Access Compliance Report

Public Rights-of-Way

(Curb Ramps)

Intersection ID: 11446	Main Street: GRACE_ST	Cross Street: PEGRAM_ST	Location: SE
ADA ID: 5C9CA99E529C	Ramp Type: BlendTrans2	Initial Pass/Fail: Pass	Overall Compliance: No
		Severity Score: 15

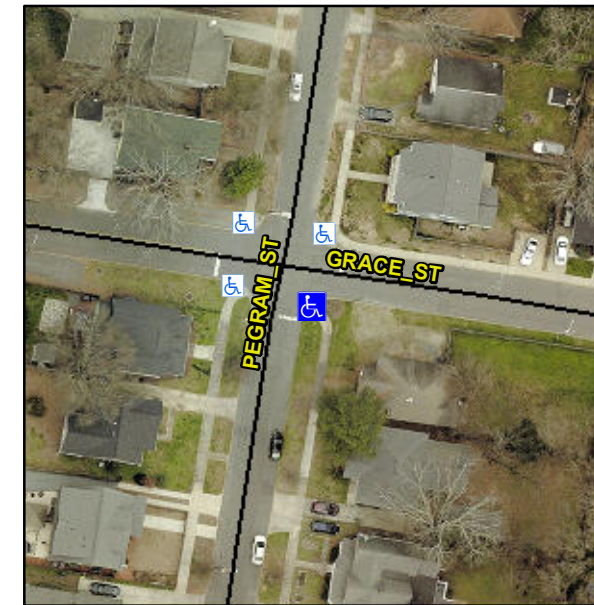
Not Found, R305.2, R302.7.2

Compliance	Description	Data	Compliance	Description	Data
N/A	Ramp Length (in)	30.0	Yes	BlendTrans Slope (%)	0.1
Yes	Ramp Width (in)	48.0	Yes	BlendTrans XSlope (%)	1.1
N/A	Flare Type LT	Sloped	N/A	Flare Type RT	Sloped
N/A	Flare Slope LT (%)	N/A	N/A	Flare Slope RT (%)	N/A
N/A	Flare Traversable LT?	No	N/A	Flare Traversable RT?	No
N/A	Landing Length (in)	N/A	Yes	DWS Provided?	Yes
N/A	Landing Width (in)	N/A	Yes	DWS Contrast?	Yes
N/A	Landing Slope (%)	N/A	Yes	DWS Length (in)	24.0
N/A	Landing X Slope (%)	N/A	Yes	DWS Full Width?	Yes
N/A	Landing Curb? (Y/N)	No	No	DWS Offset (in)	4.0
N/A	Shared Landing?	No			
Yes	Gutter Ponding?	No	Yes	Gutter Slope (%)	3.8
No	Gutter Lip Ht (in)	1.0	Yes	Gutter X Slope (%)	0.7
N/A	Painted X Walk1?	No	N/A	Painted X Walk2?	No
	X Walk 1 Direction	To N		X Walk 2 Direction	To W
	X Walk 1 Width (in)	N/A		X Walk 2 Width (in)	N/A
	X Walk 1 Slope (%)	5.6		X Walk 2 Slope (%)	3.5
	X Walk 1 X Slope (%)	3.2		X Walk 2 X Slope (%)	4.4

N/A	Ramp inside XWalk1?	N/A	N/A	Ramp inside XWalk2?	N/A
	Road Slope (%)	0.9		Clear Space?	Yes
	Road X Slope (%)	0.2	N/A	Clear Space to XWalk (in)	N/A
Yes	Any Obstructions?	No	Yes	Storm Grate/Utility Hazard?	No
	Obstruction Type			Storm Grate/Utility Type	
		N/A			N/A
			Yes	Surface Condition? (G/P)	Good
			No	Curb Slope (%)	13.3

Remove & Replace Curb Ramp With Two New Directional Ramps or Equivalent.
